MARQUETTE CITY PLANNING COMMISSION
Tuesday, September 02, 2025, at 6:00 p.m.
Commission Chambers at City Hall – 300 W. Baraga Ave.

TO: Planning Commission
FROM: Andrea Landers, Zoning Official
DATE: August 28, 2025
SUBJECT: 07-SPR-09-25 (01-PUD-03-25) – Final Site Plan Review for W. Magnetic St
(Portion of PIN: 0410681)

VERIDEA GROUP
MARQUETTE GENERAL HOSPITAL SITE RE-DEVELOPMENT

Sheet ES201

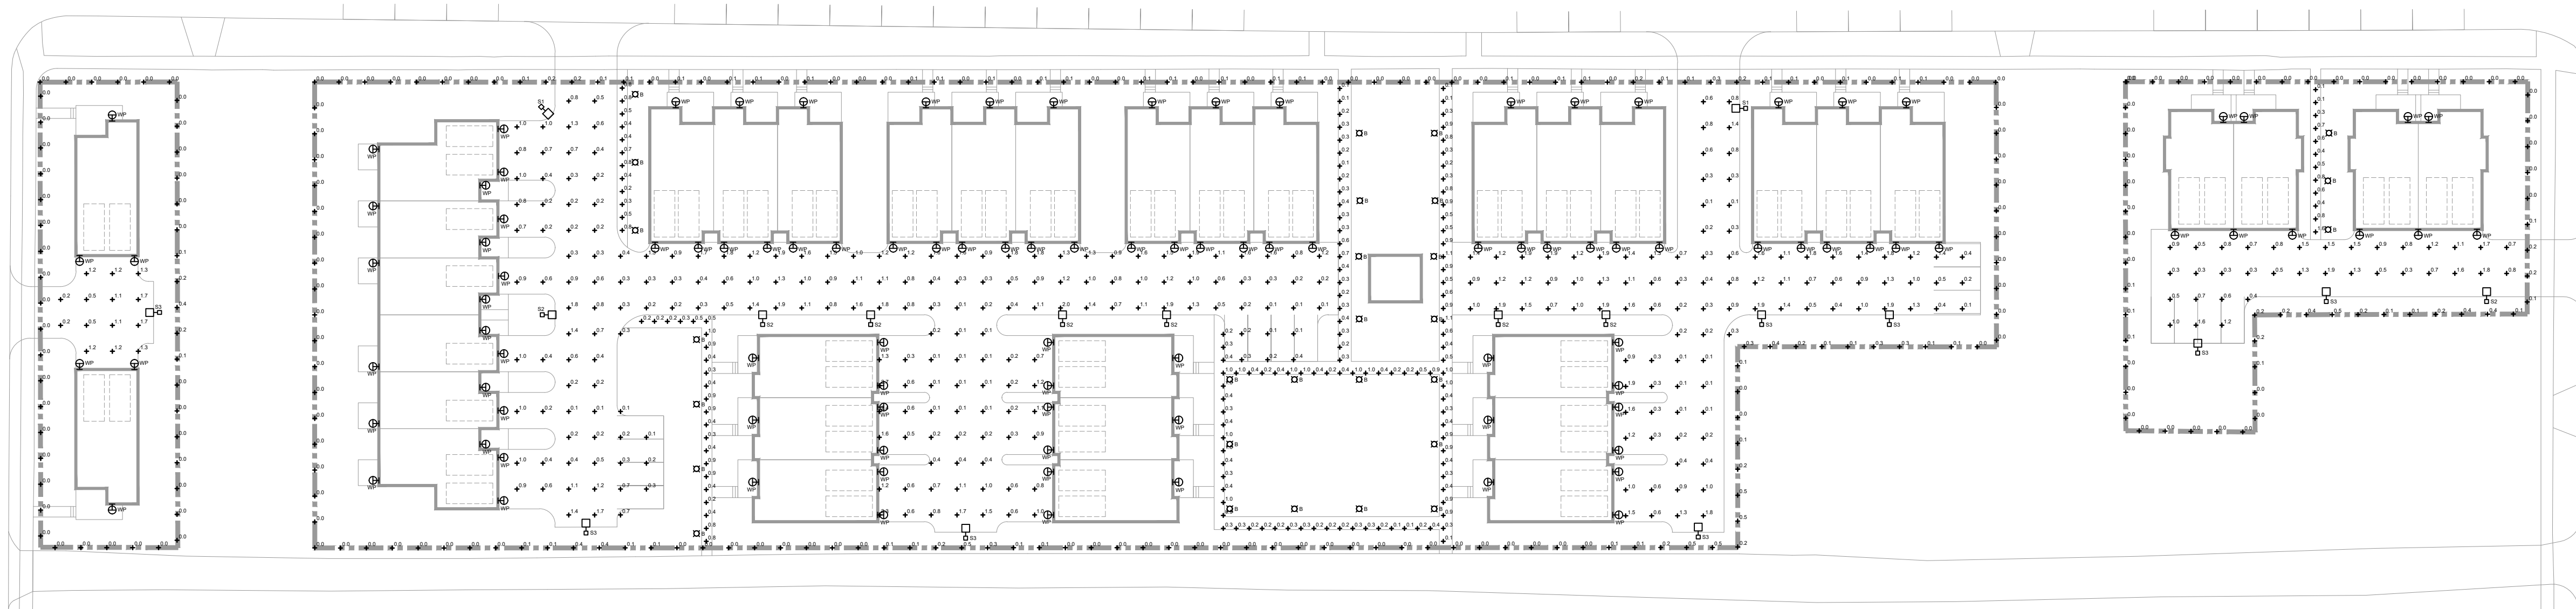
1. Per the LDC, **“Height.** The height of light fixtures on a light pole shall be measured from the finished grade to the top of the fixture”. On the exterior lighting schedule it states, “mounted to a 20-ft pole”, is this measurement including the base of the pole, i.e. measured from the finished grade to the top of the fixture? Please provide a statement on this sheet stating that or a detail showing how this requirement is being met. **Architect shall clarify total height information to the Lighting plan Sheet ES201 (20 overall feet from finished grade to top of fixture maximum).**
